STAFF COMMENTS FOR PLANNING COMMISSION

SITE PLAN: **CSP-06-003**

TITLE: **One Bank Street**

REQUEST: **CONCEPT PLAN APPROVAL**
For subdivision and development of additional bank building

CONCEPT SITE PLAN
LOT 1, BLOCK C
DIAMOND FARM
9TH ELECTION DISTRICT - CITY OF GAITHERSBURG - MARYLAND

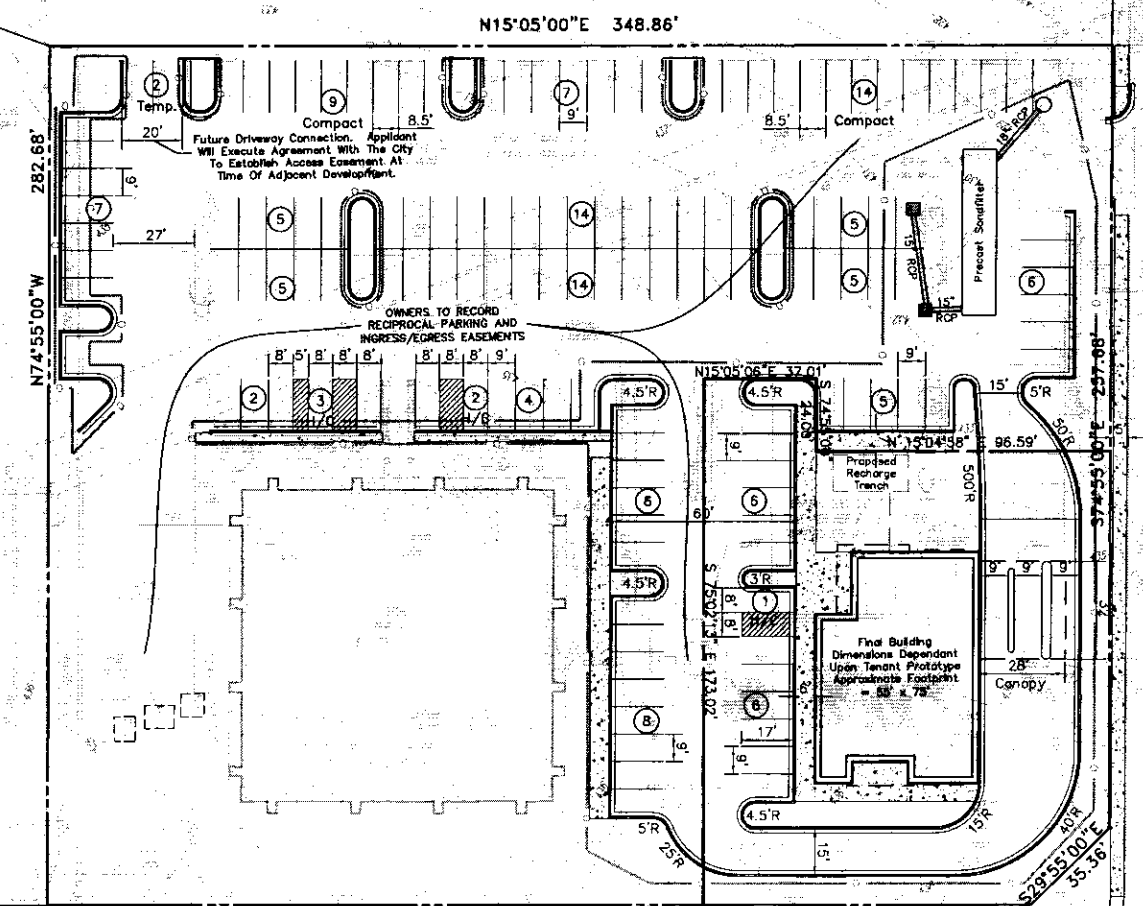
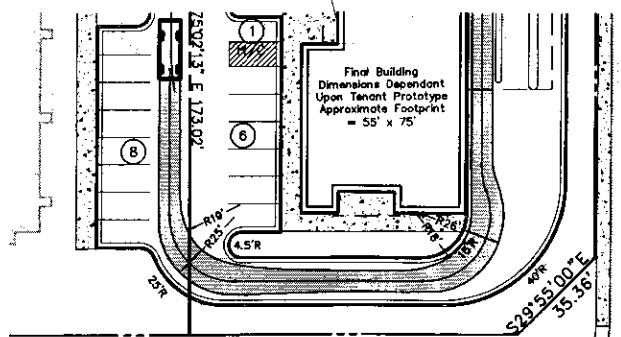
The bank is planned to have three drive-up windows on the north side of the building. The required thirteen (13) parking spaces are located on the south side of the building. The applicant will be requesting a parking waiver at the time of final site plan in order to permit 9x17 parking spaces instead of 10x17 spaces required for bank parking per Section 24-218(a)(1) of the Zoning Ordinance. Staff had suggested to the applicant that the nine foot spaces in the current configuration were preferable to the applicant's initial layout, which provided parking fronting Quince Orchard Road, with the building set further back on the site.

Staff has requested that the applicant allow space for a 20-foot wide driveway connection to Lot 8, Block C (directly west of the subject site) so that a connection between the two parcels could be made in the future. This connection had been pursued by the property owners of Lot 8 at the time that a final site plan was approved for that site (SP-02-006). That site plan has since expired. However, the

connection is still desirable. The applicant has indicated a future access on the site plan. Two parking spaces will be lost once the connection is made. However, these parking spaces have not been included in the parking chart.

1. Buildings, drive aisles, sidewalks and parking spaces and been dimensioned on the site plan.
2. Paving in Bank Street adjacent to the proposed turn lane modifications has been shown to be milled and overlaid.

3. The recordation of an ingress/egress easement between the two lots has been noted on the plan and can be made a condition of concept plan approval.
4. A parking space adjacent to 1 Bank Street has been eliminated as requested.

5. A five foot sidewalk along Bank Street is shown adjacent to the existing curb. Existing grades, utilities and vegetation does not allow us to place a green strip between the walk and curb.

6. Future property lines have been annotated.
7. A future twenty feet wide driveway connection has been shown to access future development on Lot 8, Block C. The applicant agrees to enter into an agreement with the City, granting a mutual access easement at such time that Lot 8 is developed.

8. Parking spaces adjacent to the bank are shown as nine feet in width as per discussions with Ollie Mumpower. We understand that as per Section 24-218(a)(1) of the Gaithersburg Zoning Ordinance banks are required to provide ten foot wide "high-turnover" parking spaces. The conversion of nine foot spaces to ten foot spaces would result in the loss on one space and put us one space short of the required parking for both lots. Given that we have voluntarily given up parking in other areas of the site to provide an access drive to Lot 8 and to add additional green space, we feel that a waiver of the ten foot width is reasonable so that we may meet our parking requirements.

5. Even with the addition of a parking island for the future driveway connection, the parking green space for the existing office building is only 7.9%. Based on site restrictions of this redevelopment we will need to request a waiver, as per Section 24-222A(1) of the Gaithersburg Zoning Ordinance, from the 10% internal landscaping requirement (Section 24-220(e)) and hereby do so. The 7.9% proposed is substantially more than the existing 1.1% internal landscaping currently provided on the site.
